# HAVASUPAI TRIBAL COUNCIL

May 27, 2022

**Re: The Havasupai Tribe Letter of Opposition Regarding the Pinyon Plain Mine Individual Aquifer Protection Permit**

Fig. 7 Conceptual groundwater flow diagram for the South Rim, Grand Canyon, USA. Groundwater recharge sources labeled with blue text. Relative flow amounts indicated by size of flow-path arrows. Hydrogeology generalized from Fig. 2 with major features labeled with

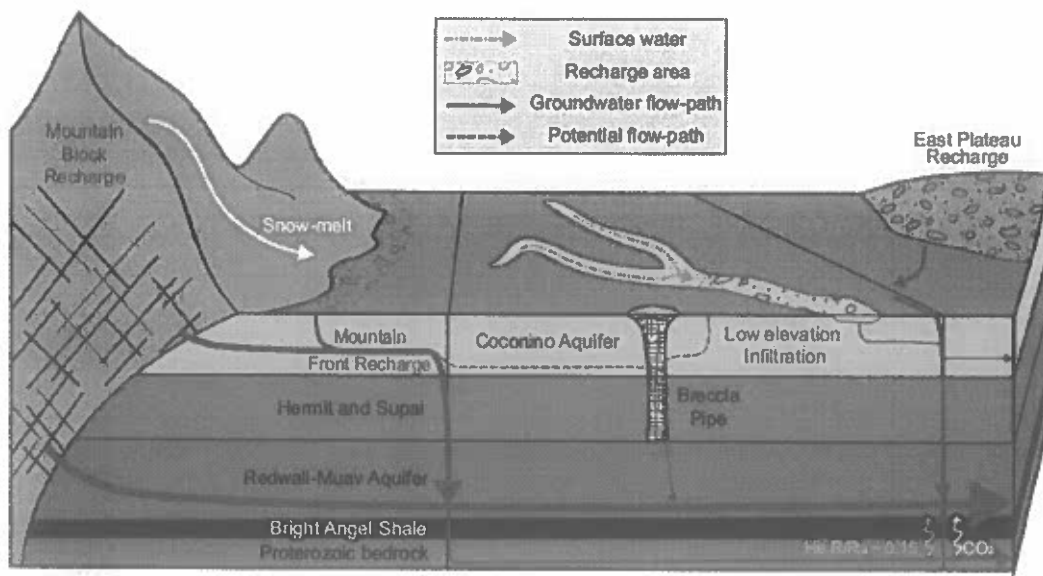
Companion studies, Solder and Beisner 2020 and Beisner et al. 2020, also do not support ADEQ’s groundwater flow model as remaining current. Collectively, these studies indicate the need for a **new** conceptual model that reflects the more complex reality of the groundwater flow path and recharge on the South Rim and where the Pinyon Plain Mine is located.
